24050-05-001

PROPOSED HOUSING DEVELOPMENT AT CHERRY ORCHARD, DUBLIN

Stage 1 Quality Audit

(Incorporating a DMURS Street Design Audit, and Audits
of Accessibility, Cycling, Walking and Road Safety)

Figure 6.1 – Proposed Trees and parking compromising intervisibility of pedestrians and motorist at crossings

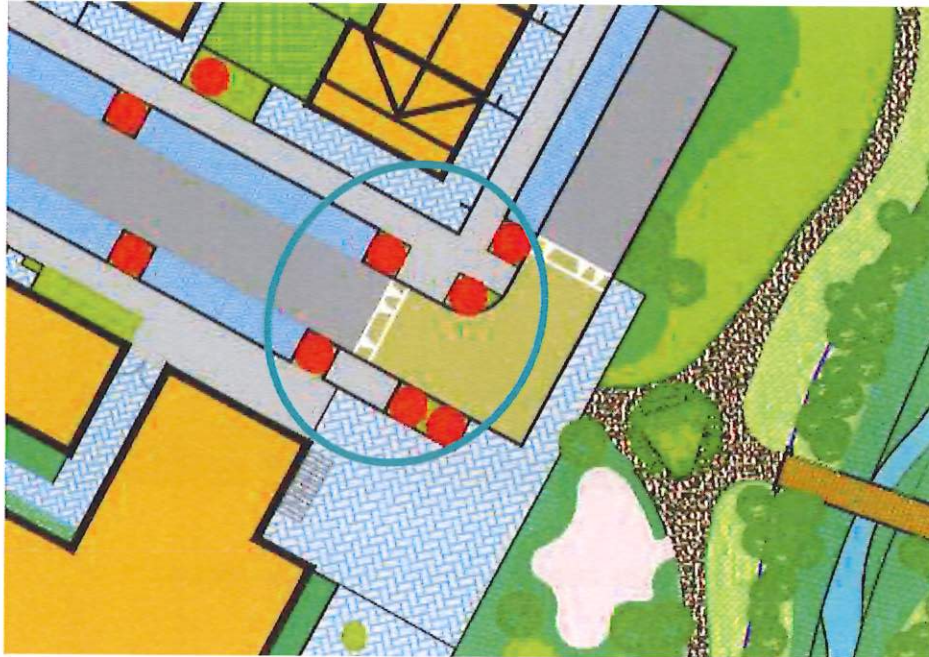
Inter-visibility between pedestrians and drivers at crossings in the proposed development may be significantly compromised by the proposed trees and parking locations. This may increase the risk of collisions and pedestrian injuries at these locations because of trees and parking including, but not limited to, that circled in Figure 6.1.

Ensure adequate inter-visibility between pedestrians and drivers at pedestrian crossings. Relocate trees and parking as appropriate.

6.1	Yes	Yes	-----	-----
6.2	Yes	Yes	-----	-----
6.3	Yes	Yes	-----	-----
7.1	Yes	Yes	-----	-----
7.2	Yes	Yes	-----	-----
8.1	Yes	Yes	-----	-----
8.2	Yes	In Part	Railings and tactile paving will be provided at steps/ ramps. We have provided a gently grading slope to the remainder of the woodland look walk as an alternative amenity.	Yes

Figure 6.2 – Dominant Pedestrian Desire Lines

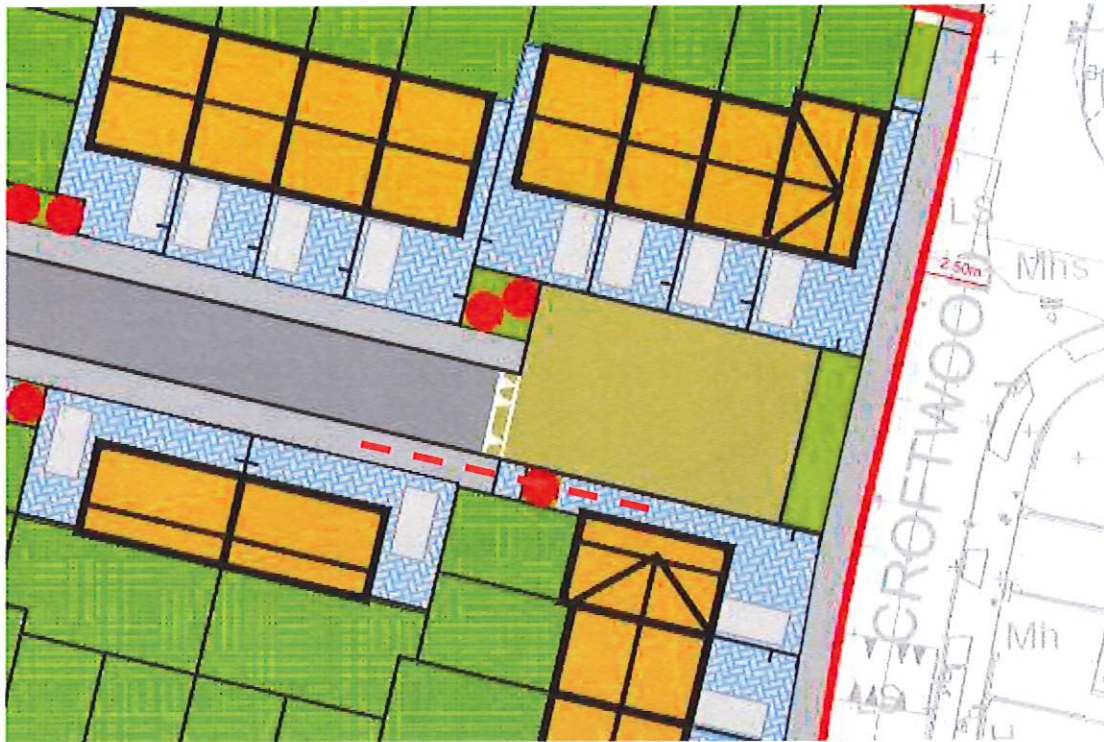
All pedestrian desire lines within the proposed development do not appear to be met by the infrastructure or feature substandard infrastructure for walkability as outlined by the dashed line in Figures 6.2.

Ensure all desire lines across the development and each individual junction are facilitated with adequate walking infrastructure.

Figure 7.1 – GDA Cycle Network (www.nationaltransport.ie/wp-content/uploads/2023/01/2022-GDA-Cycle-Network.pdf)

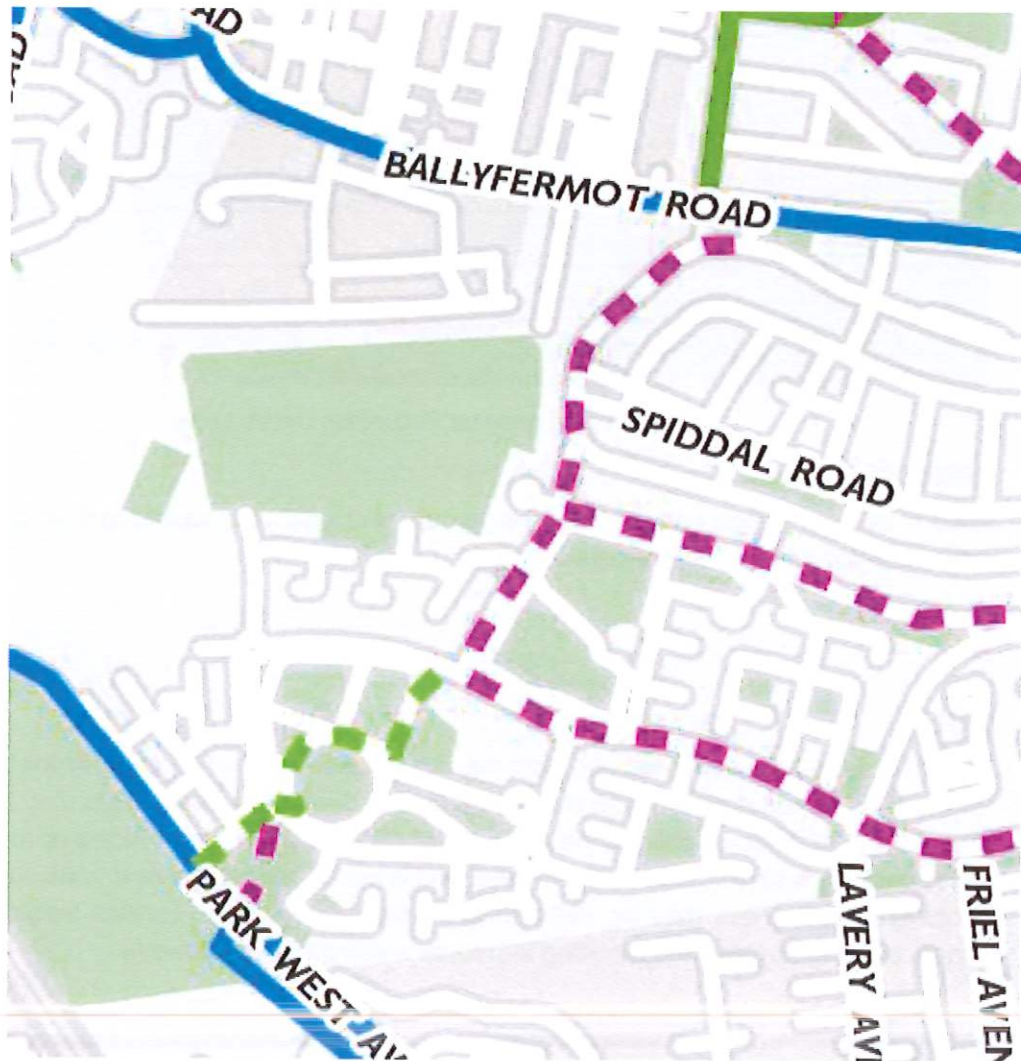
As there is no proposed cycle infrastructure in the development, it is not clear how the development will tie into the proposed 'Feeder' Routes (dashed pink line in Figure 7.1) or 'Greenway – Leisure' Routes (dashed pink line in Figure 7.1) adjacent to the development. A lack of coordination may reduce the effectiveness of these schemes, proposed by Dublin City Council and National Transport Authority, and undermine potential to achieve cyclist desire lines.

Consider wider network impacts of future schemes to support Provide a network of segregated cycleways through the development. Consult with Dublin City Council Active Travel and National Transport Authority to ensure the development is futureproofed.

Figure 8.2 – Crossings without Tactile Paving

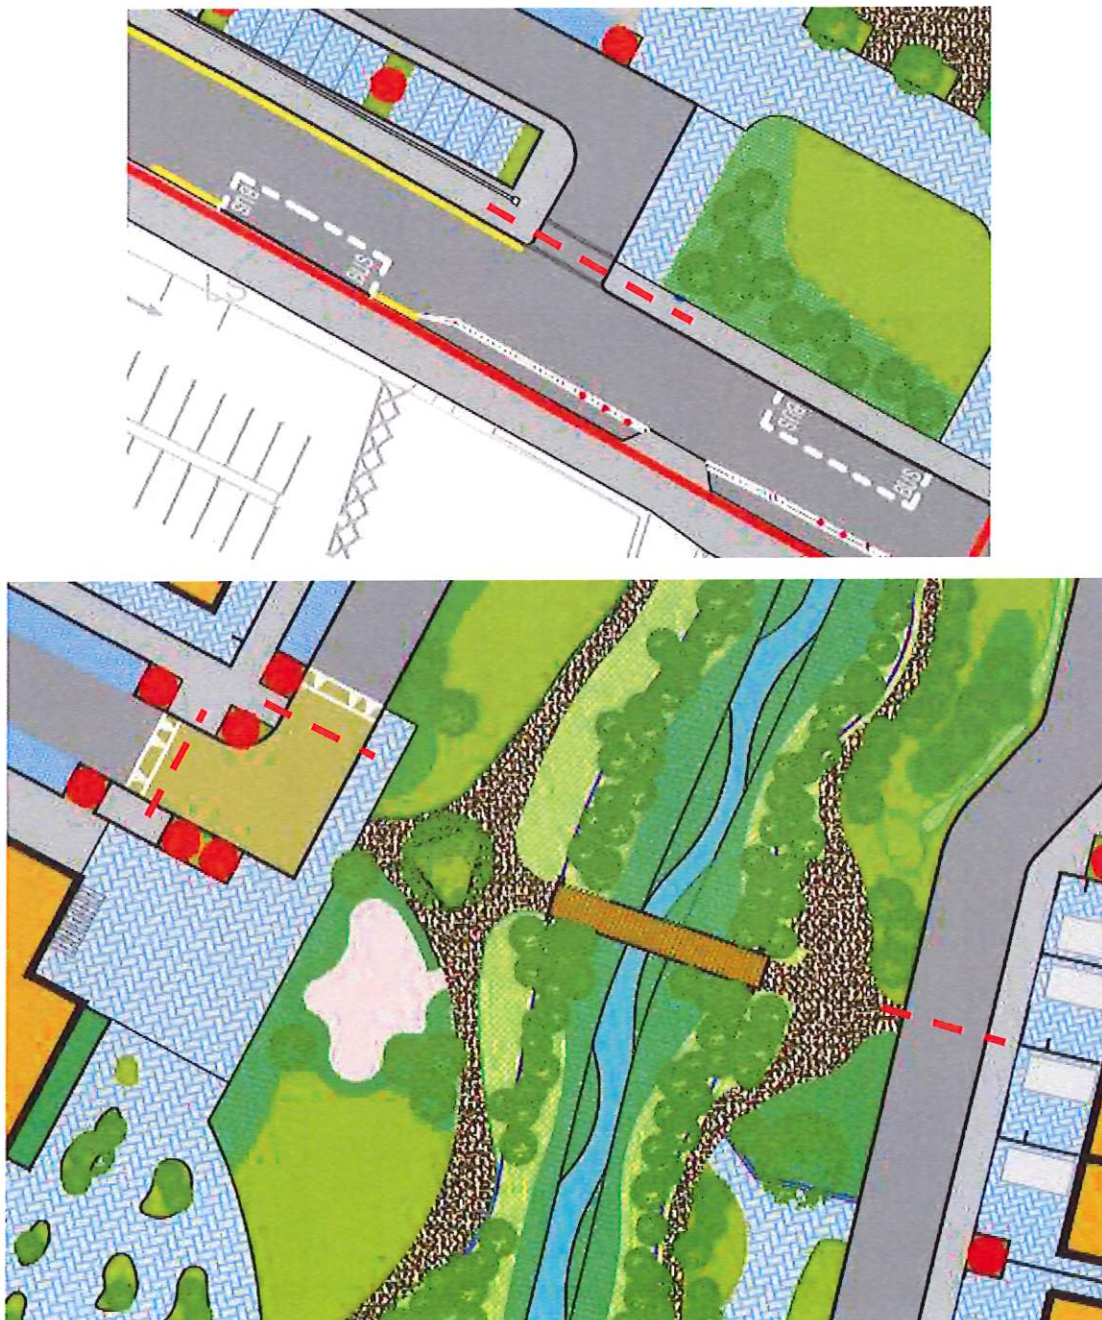
Certain crossing points or desire lines including, but not limited to, the locations shown below do not feature tactile paving. This may result in disorientation or confusion of vision impaired users.

Ensure adequate tactile paving for all internal crossings.

8.3	Yes	In Part	The crossing at Cherry Orchard Ave is proposed to be a continuous footpath. The other crossings will have tactile paving.	Yes
8.4	Yes	Yes	-----	-----
